<b>Grand Canyon Unified School District, #4</b> Amendment #1		100 Boulder Street Grand Canyon Village, AZ 86023
	IFB: 21-02-21 PROJECT: Playground Fence/Retaining Wall at Grand Canyon Elementary	Page 1 of 52

**Project:**  
Grand Canyon Elementary  
Retaining Wall Replacement

SFB – 030204001-9999-004-BRG  
Emc2 – 14819710  
IFB – 21-02-21

## AMENDMENT NO. 01

A5 FLOOR PLAN DEMO

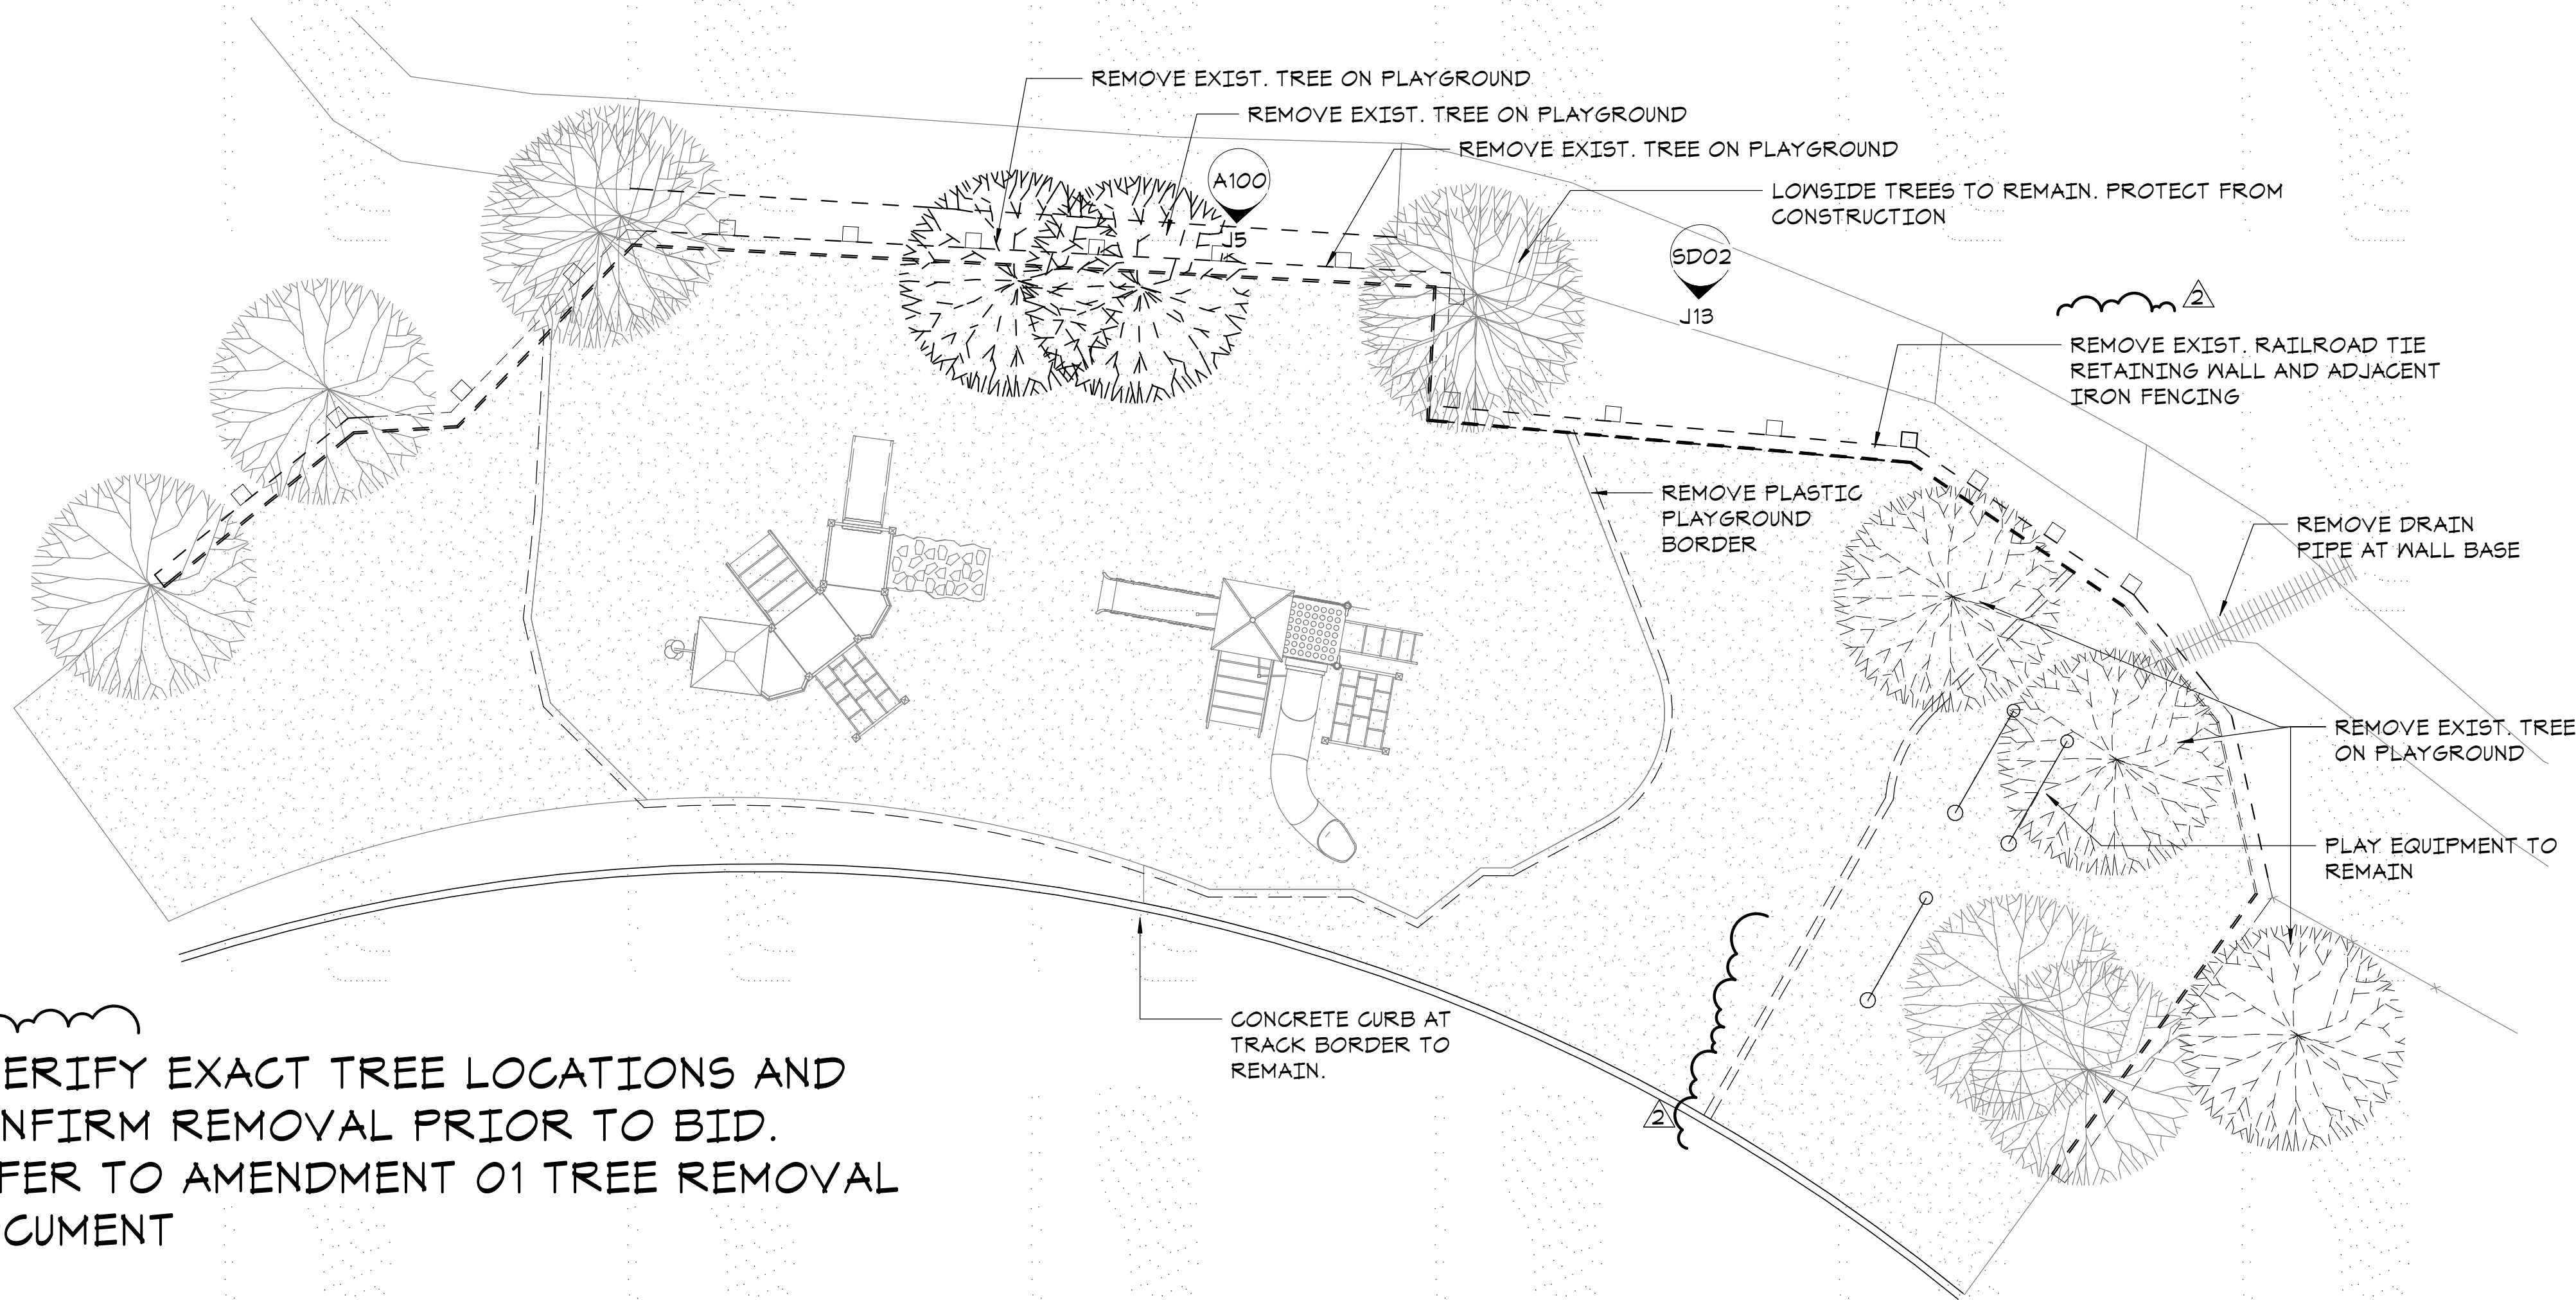
Sheet A100 – Detail A5 revised to show additional existing condition information.  
Sheet A101 – Detail A5 revised to include additional 2" of recycled rubber playground fall protection to match existing.
